## COUNCIL ASSESSMENT REPORT

<b>Panel Reference</b>	2018ECI015
<b>DA Number</b>	DA-2016/276/B
<b>LGA</b>	Bayside Council
<b>Proposed Development</b>	S4.55(2) Application - Modification to change rear colorbond fence to masonry, add accessible toilet to rooftop open terrace, change front facade material, modify window openings to southern elevation and change street number from No. 4 to No. 6
<b>Street Address</b>	4 Innesdale Road, Wolli Creek
<b>Applicant/Owner</b>	VP1 Pty Ltd
<b>Date of DA lodgement</b>	26/11/2018
<b>Number of Submissions</b>	Nil
<b>Recommendation</b>	Approval subject to conditions
<b>Regional Development Criteria (Schedule 7 of the SEPP (State and Regional Development) 2011)</b>	Affordable Housing CIV >\$5M  The proposal as modified is referred to the Regional Panel for determination, as required by clause '123BA - Functions exercisable by council on behalf of regional panel' of the Environmental Planning and Assessment Regulation 2000.

## Planning Assessment Report

<b>Application Number:</b>	DA-2016/276/B
<b>Date of Receipt:</b>	26 November 2018
<b>Property:</b>	4 Innesdale Road, WOLLI CREEK (Lot 15 DP 4032)
<b>Owner:</b>	VP1 Pty Ltd
<b>Applicant:</b>	VP1 Pty

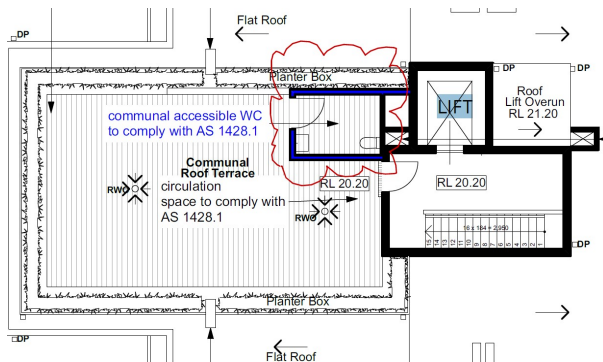
Further to the above, it is proposed to alter a portion of the previously approved materials to the streetscape (southern elevation) as follows;

<i>Approved Finish</i>	<i>Proposed Finish</i>
Frosted glass on solid spandrel	White Coloured Fibro Panel
White coloured perforated panel	Painted Fibro Panel on solid spandrel

The proposed change in materials is not unreasonable and does not adversely impact upon the appearance of the development.
